CHRYSLER A604 (41TE) UPDATE HANDBOOK

*Updated
May, 2003*

"UPDATE HANDBOOK"

Figure 15

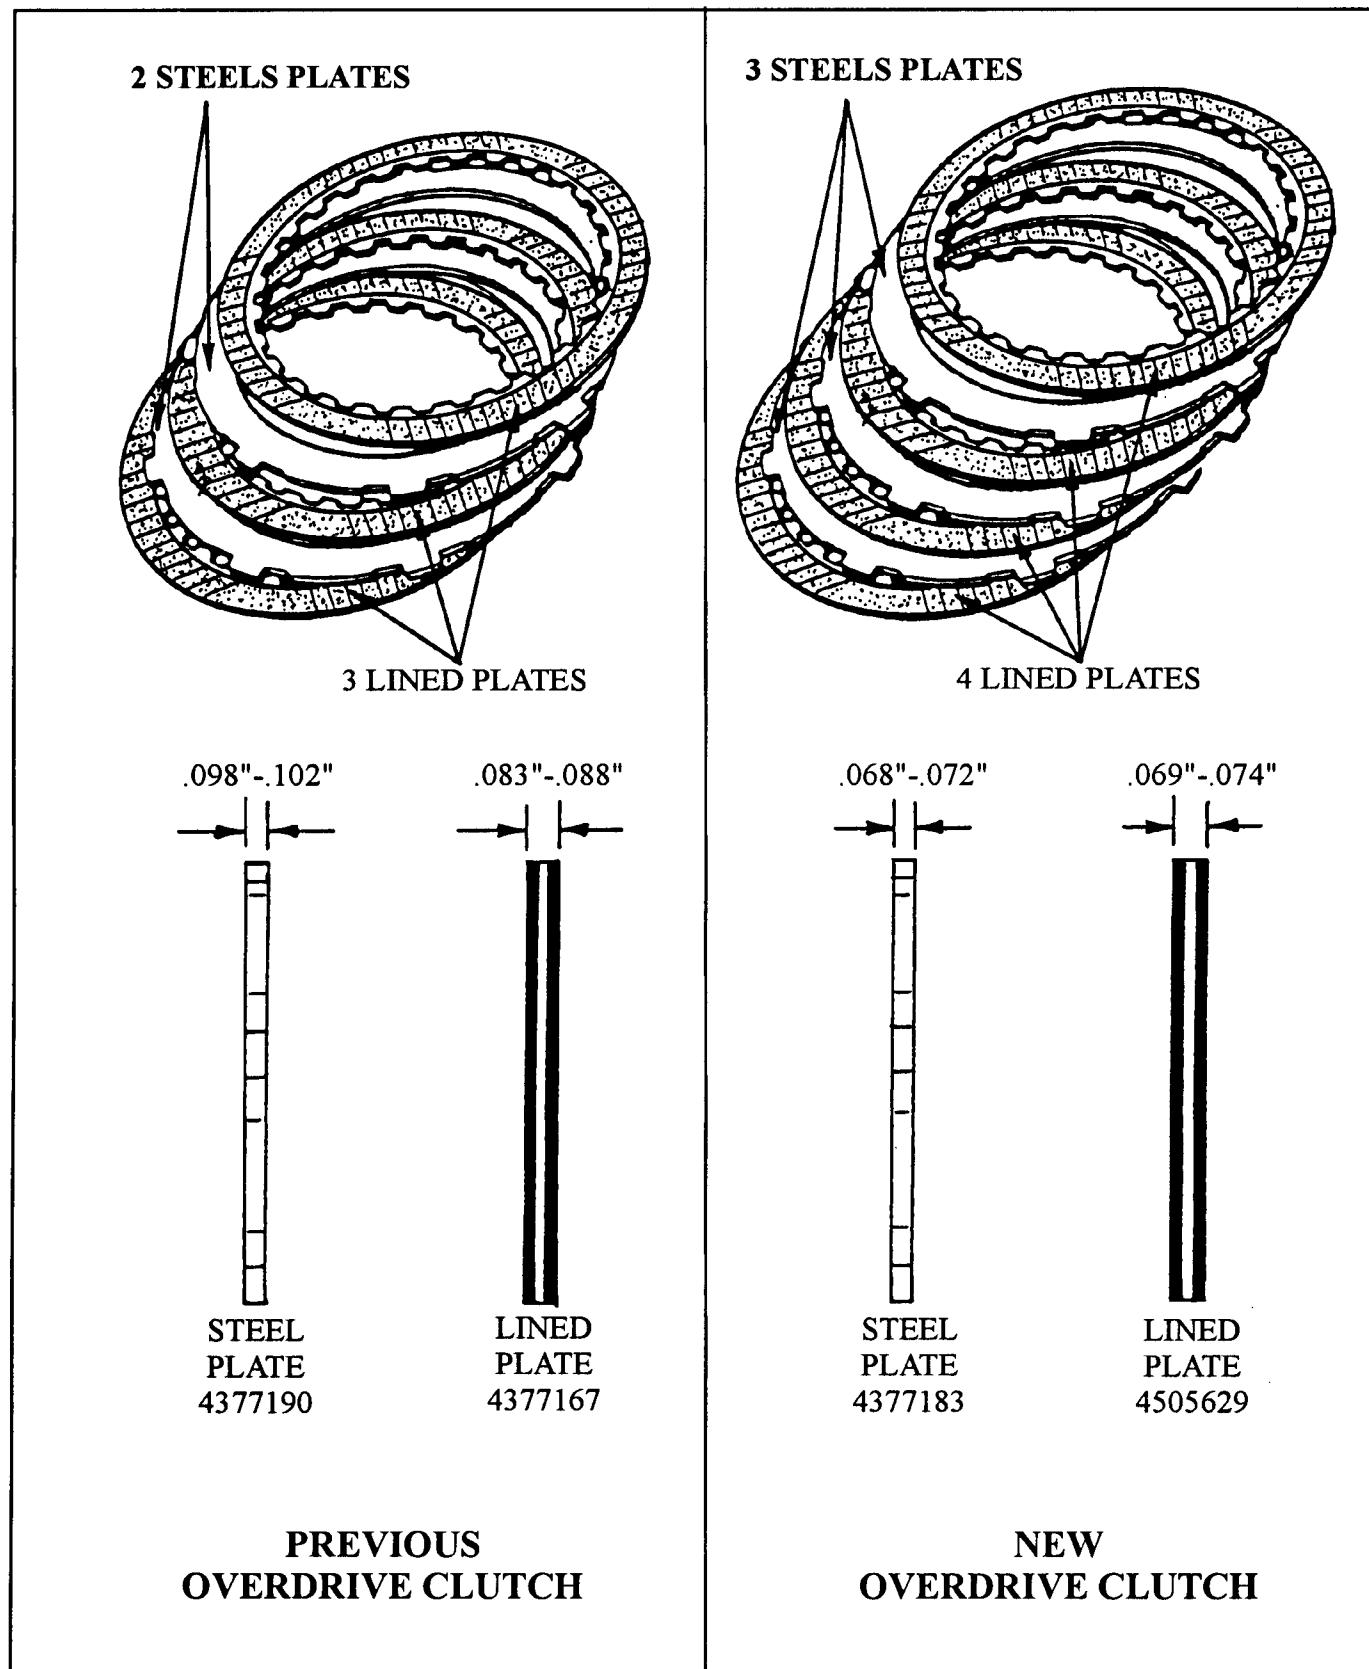
CHANGE: A running change for 1990 model A604 transaxles was the introduction of a four (4) disc Overdrive Clutch Assembly, to replace the previous three (3) disc clutch assembly (See Figure 15).

- (1) **OVERDRIVE LINED PLATES** - Now uses 4 lined plates instead of the previous 3 lined plates, and the lined plates for 1990 models are .014" thinner than the 1989 lined plates (See Figure 15), to help accommodate the extra lined plate. The 1989 lined plates measure .083"-.088" thick, and the new lined plates will measure .069"-.074" thick (See Figure 15).

- (2) **OVERDRIVE STEEL PLATES** - Now uses 3 steel plates instead of the previous 2 steel plates. The new steel plates are .030" thinner, and measure .068"-.072" thick. The previous steel plates measure .098"-.102" thick (See Figure 15).

Figure 16

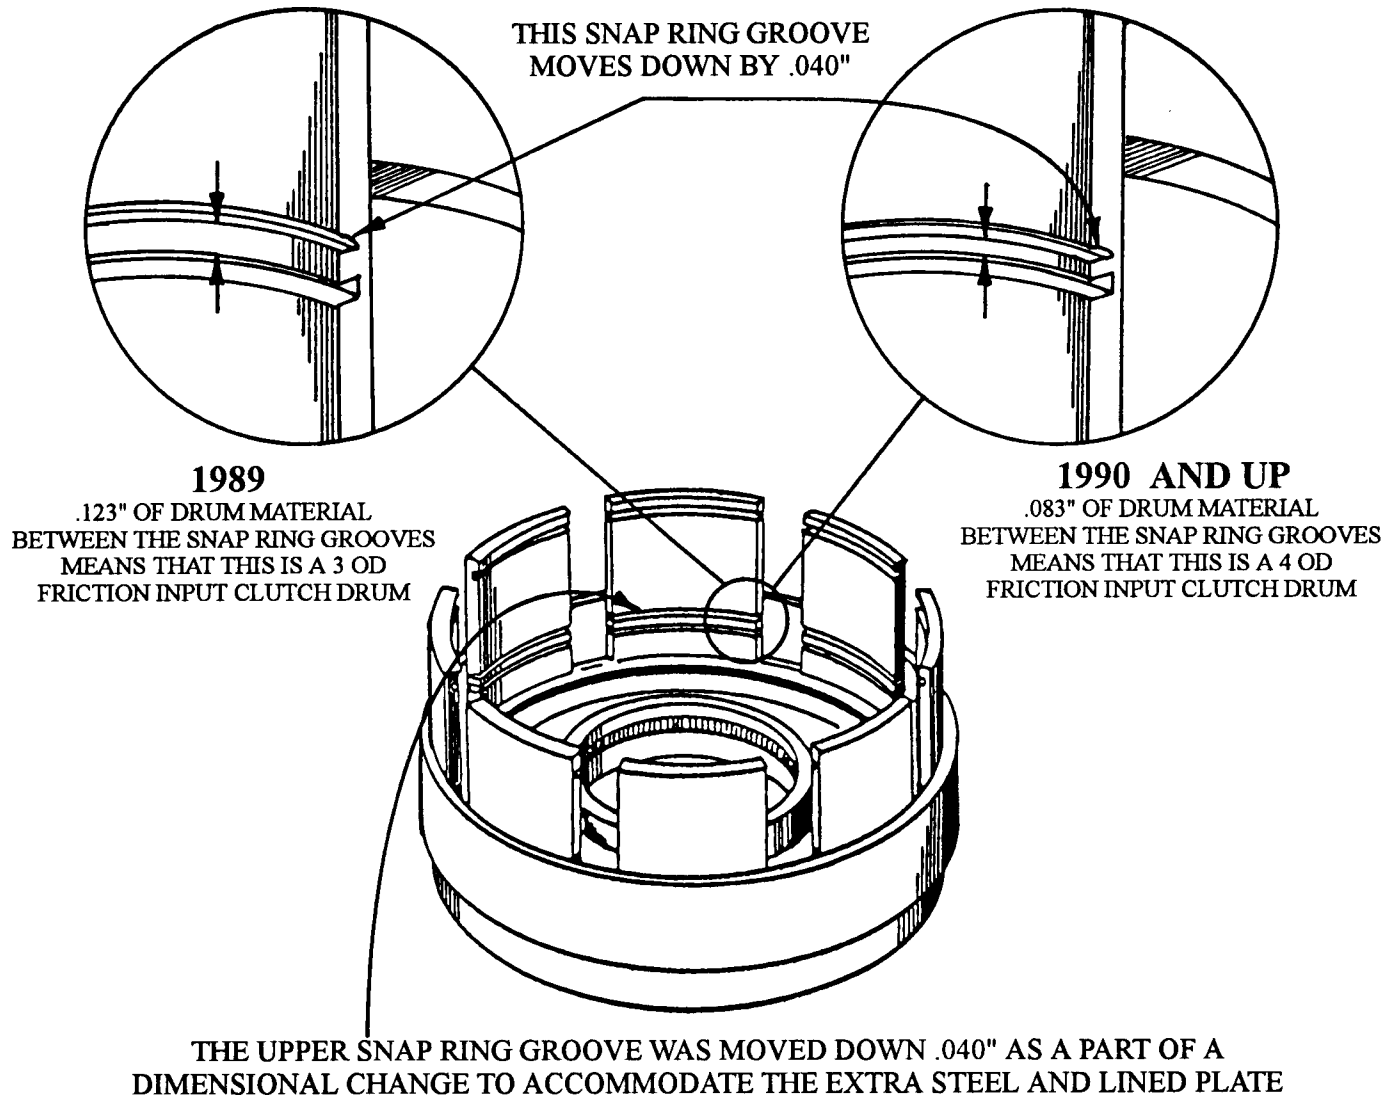
- (3) **INPUT CLUTCH RETAINER** - The underdrive/overdrive reaction plate tapered snap ring groove was moved "Down" by .040" (Can be detected visually) to make room for the added lined and steel plates (See Figure 16). This also necessitated a change to be made to the underdrive/overdrive reaction plate as explained below. Another change that occurred at the same time is the underdrive clutch outer lip seal groove depth is .040" "Shallower" to accommodate a new underdrive clutch outer lip seal (See Figure 17).

Figure 17

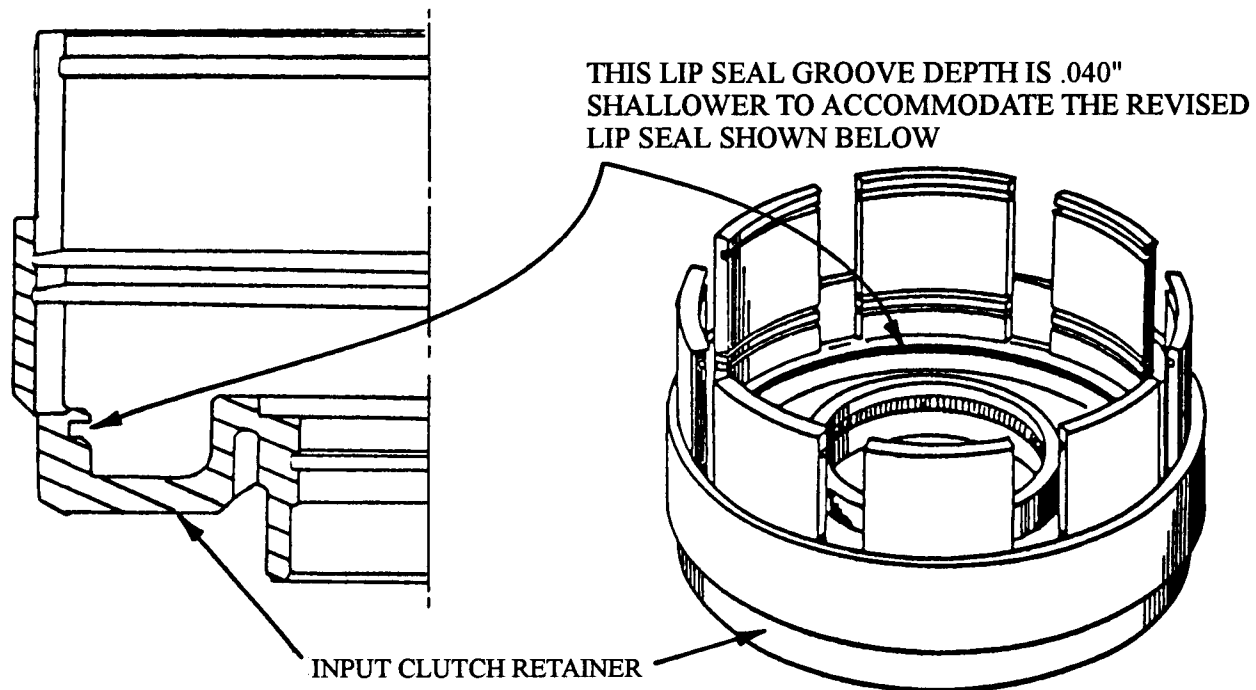
- (4) **UNDERDRIVE CLUTCH OUTER LIP SEAL** - The lip seal cross section has been reduced by .040" (Smaller in Overall Diameter) to accommodate the change in the depth of the groove in the input clutch retainer (See Figure 17). The OEM part number is printed on the seals for identification. The 1989 (Large) is 4377173, and the 1990 (Small) is 4531408. This will confirm that you have the proper seal for this location (See Figure 17).

Figure 28

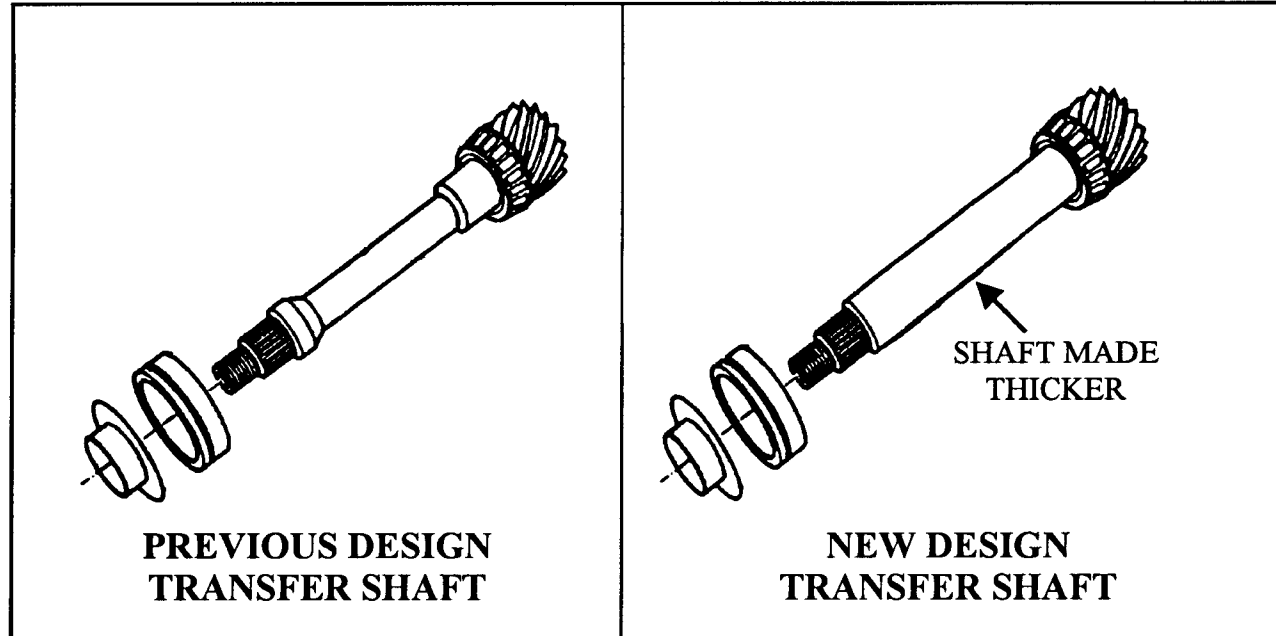
CHANGE: A thicker transfer shaft was made as a running change in 1990 and continues through to current production (See Figure 28).

- (1) **TRANSFER SHAFT** - The transfer shaft between the transfer gear end and the threaded end of the shaft increased in diameter to accommodate torque transfer (See Figure 28).

Figure 29

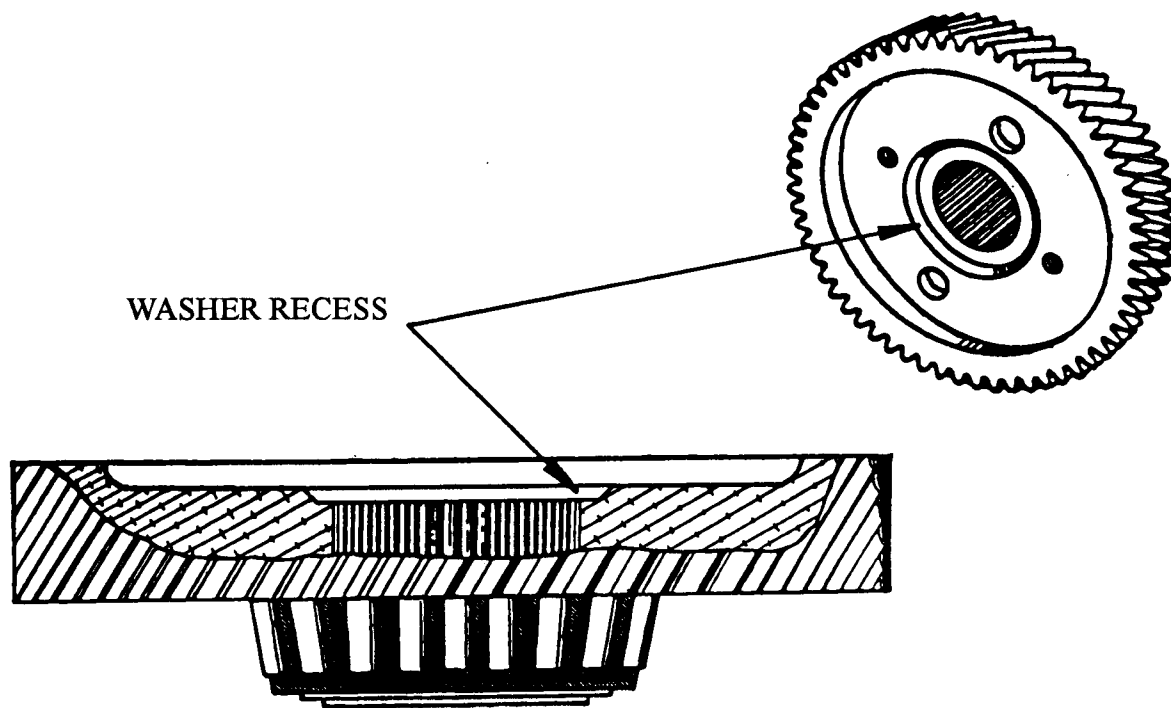
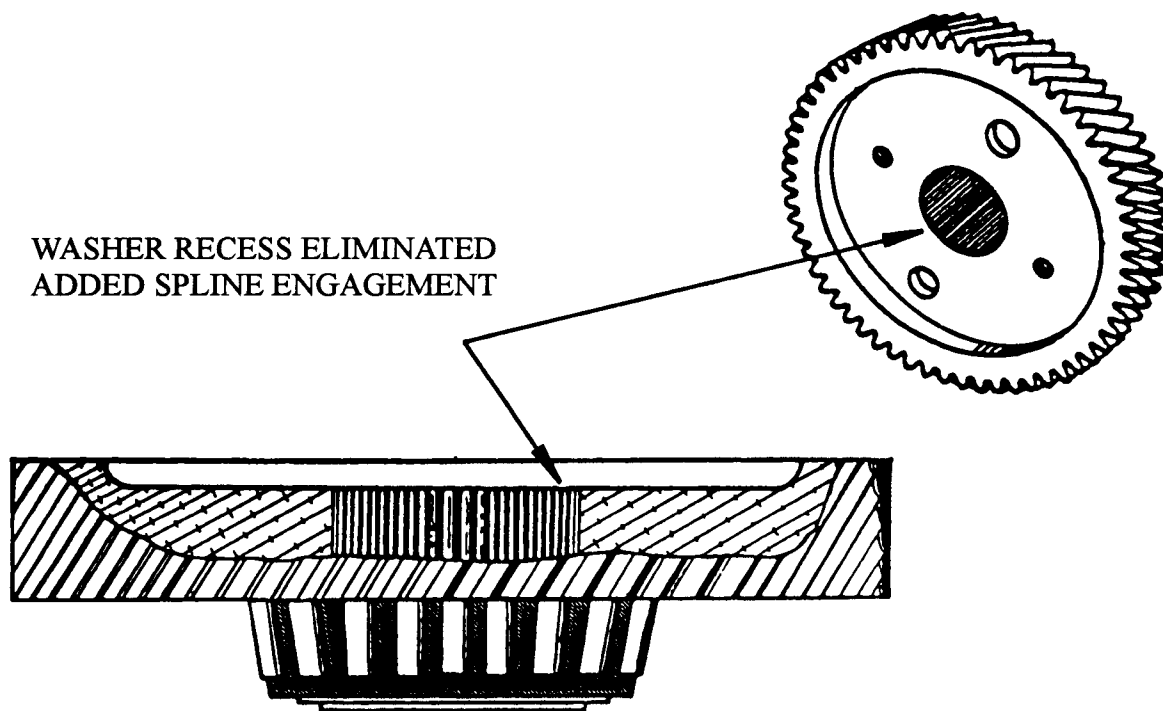
- (1) **TRANSFER GEARS** - The helix angle of the teeth on both transfer gears changed from 27.5 degrees to 32 degrees. The new design transfer gears can be easily identified by the removal of the washer recess area in the center of the gears, as shown in Figure 29. This was done to create more spline engagement, to accommodate higher torque engines.

Figure 38

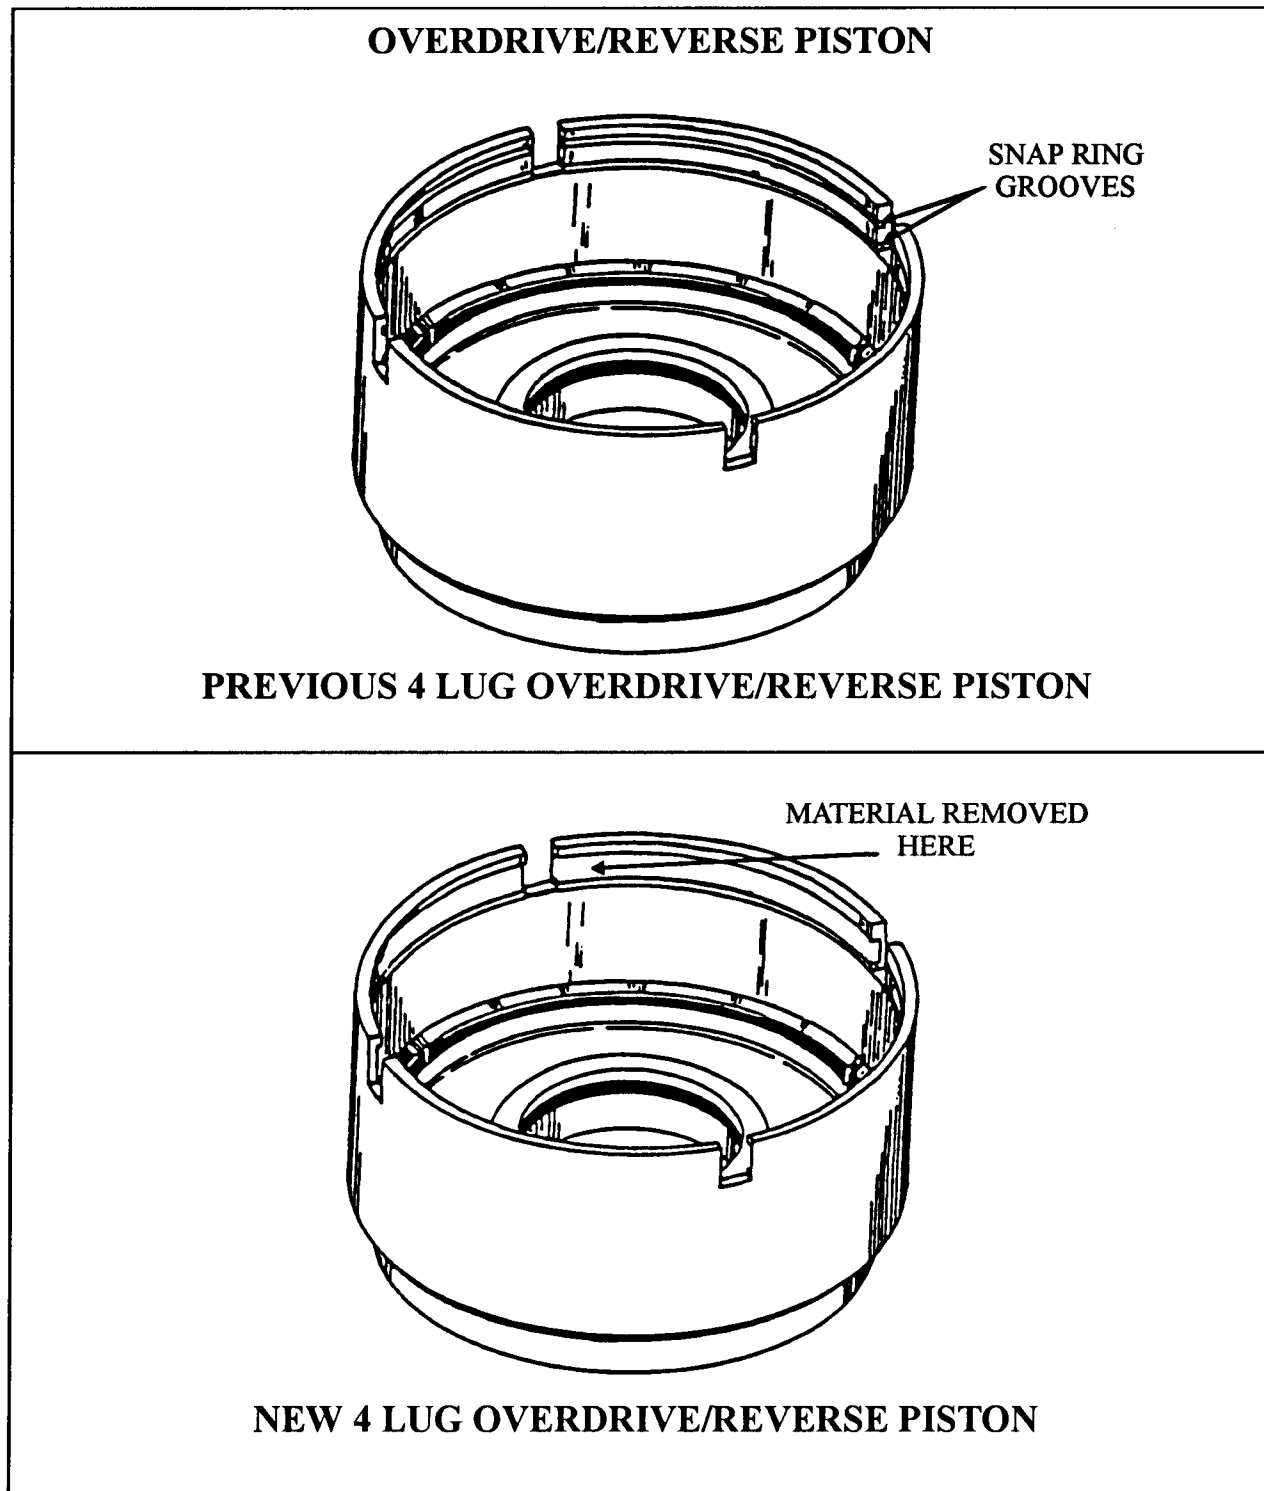
CHANGE: A 1991 running change was made to the overdrive/reverse piston, eliminating the material between the two snap ring grooves (See Figure 38).

REASON: To prevent the possibility of the overdrive/reverse reaction plate from binding in the overdrive/reverse drum, since it is also piloted on the outside diameter (See Figure 38).

- (1) **OVERDRIVE/REVERSE PISTON** - The drum material between the previous two snap ring grooves has been eliminated, as the Overdrive/Reverse Reaction Plate is also piloted on the outside diameter (See Figure 38). The snap ring and plate "Stack-Up" is **EXACTLY** the same as previous models with the new design level piston.

Figure 39

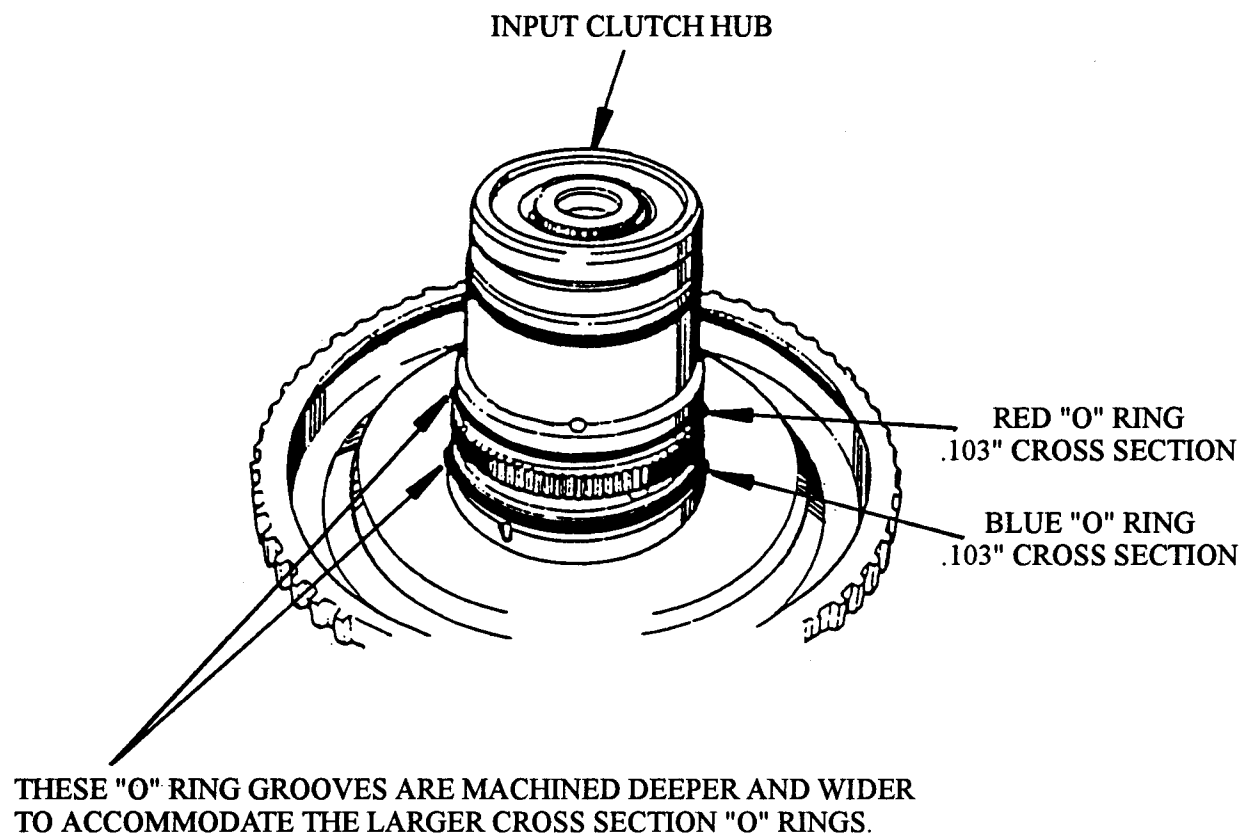
- (1) **INPUT CLUTCH HUB** - The "O" ring grooves on the Input Clutch Hub are cut deeper and wider to accommodate the larger cross section color coded "O" rings (See Figure 39).
